Sequoia Data Center

Docket 19-SPPE-03

Intervenor Sarvey's Response to Staff and Applicant on Committee Questions

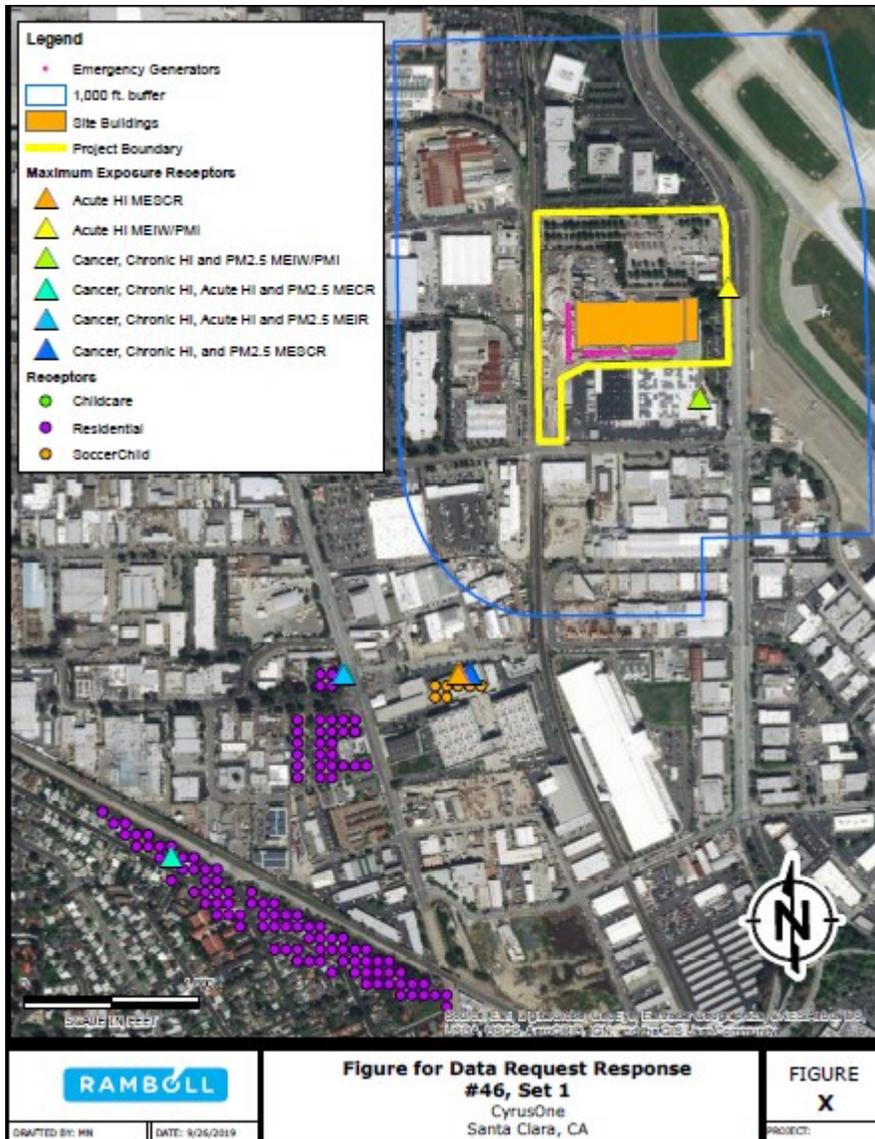
areas.” Staff’s cumulative analysis performed in response to the Committees questions found out the exact same thing. Footnote 8 on page 6 of Staff’s response to Committee questions verifies my previous assessment as, “Staff found the nearest soccer child receptor location modeled by the McLaren applicant to the Sequoia MESCRC location (only about 14 meters [46 feet] away).⁴ The youth soccer field Off The Wall Soccer is depicted below in the orange triangle.⁵ The maximum cancer, chronic and PM 2.5 impact from McLaren all occur at the youth soccer field as depicted in the blue triangle in the map below. Staff’s estimated cancer impact at that location is reported as .0081⁶ in Staffs response to the committee questions but Staff analysis in the McLaren Data Center reports a cancer impact 10 times higher at .08.⁷ Staff’s estimated cancer risk from Sequoia at the soccer facility in its response to committee questions is reported as .00031. Staff’s estimated cancer risk to the youths at the soccer facility in the IS/MND is reported as .1 which is thousands of times higher than staff reported in the response to committee questions. With these kinds of results not much faith should be given to staffs HRA analysis in either document. I would say staff’s analysis is not consistent with the BAAQMD guidelines or CEQA guidelines for a cumulative analysis.

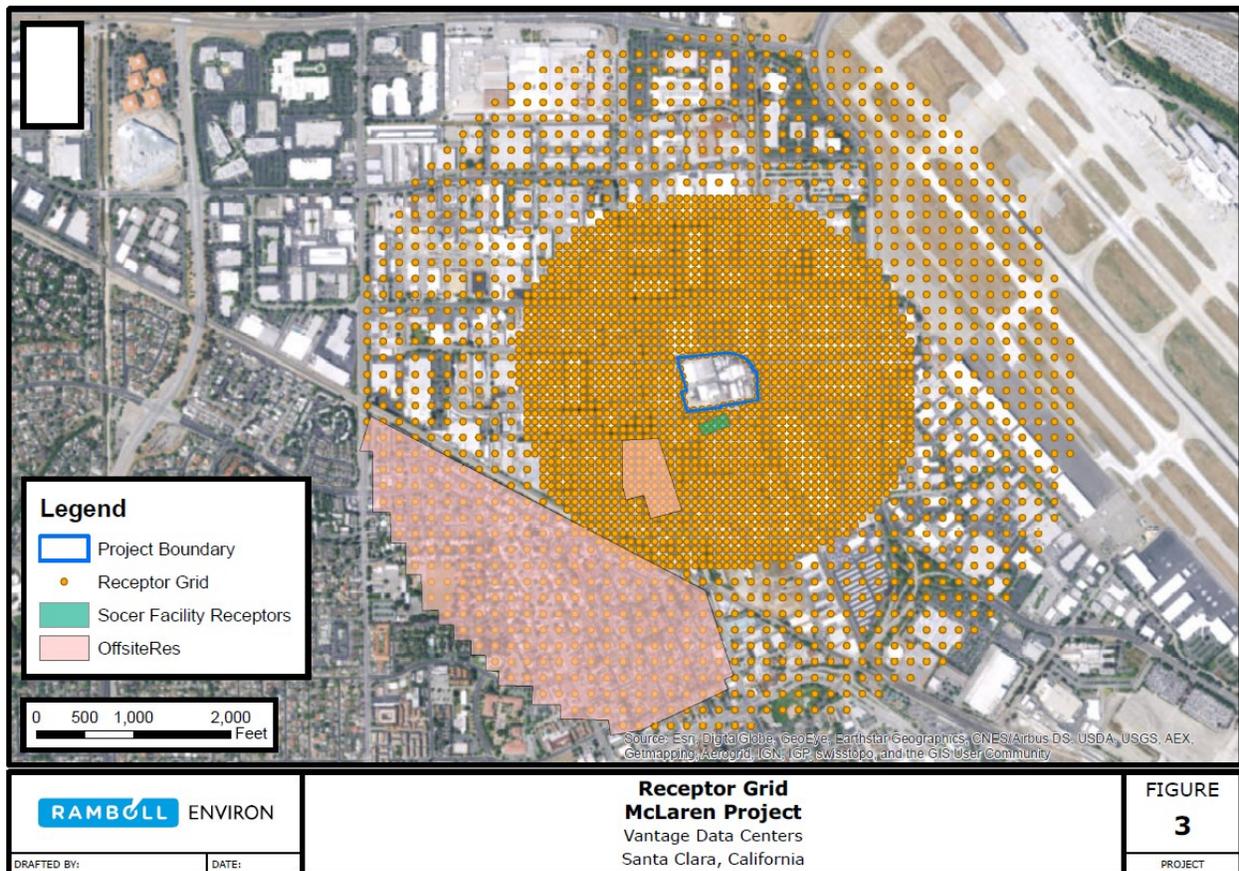
The same youth soccer field depicted above from the Sequoia data center proceeding is located across the street from the McLaren Data Center as depicted in the green rectangle in the map below from the McLaren Data Center proceeding below.
